Installation instruction for idler pulleys

Technical Info No. 1796

Audi A4 / A6 / Allroad / A8 / Skoda Superb
VW Passat / Phaeton

2.5 TDI and 4.2 V8

Fig. 1: 55459 (old version)

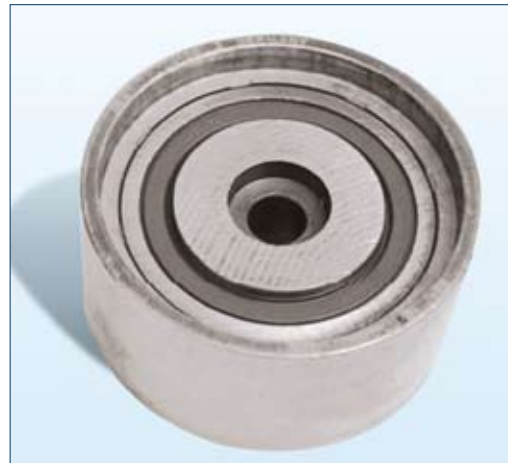
The idler pulley 55459 (Fig. 1) has been replaced by 55707 (Fig. 2).
Using the wrong screw may result in damage to the engine!

The idler pulley 55459 must be installed with a hexagon socket screw with a thread length of 40 mm.

The idler pulley 55707 must be installed with a hexagon socket screw with a thread length of 30 mm.
